**CITY OF BELLE MEADE
HISTORIC ZONING COMMISSION
REGULAR MEETING AGENDA PACKET
FEBRUARY 11, 2025, 03:00 PM**

**AGENDA HISTORIC ZONING COMMISSION
REGULAR MEETING
FEBRUARY 11, 2025, 03:00 PM
BELLE MEADE CITY HALL, 4705 HARDING PIKE**

Staff Report

Case No.: #A24-33

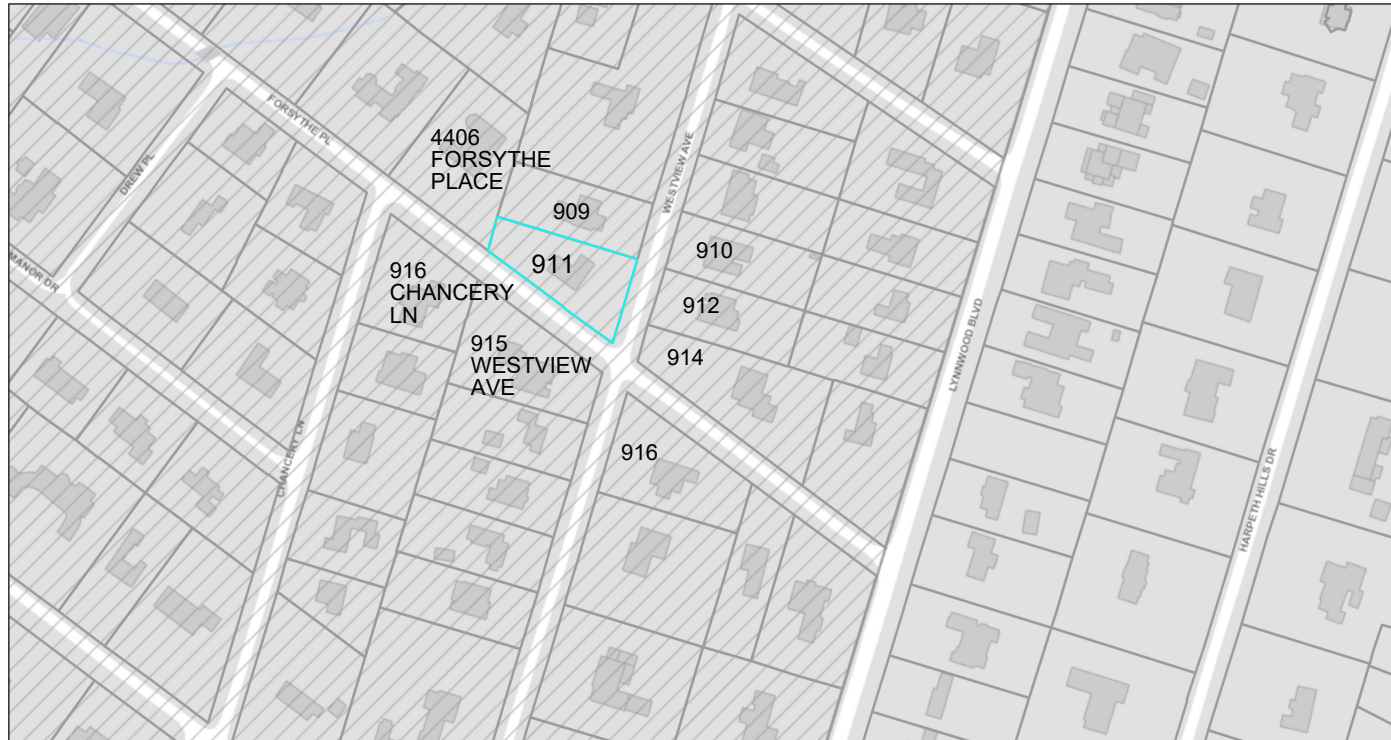
Staff note – garage door Staff note – front door material is not stated.
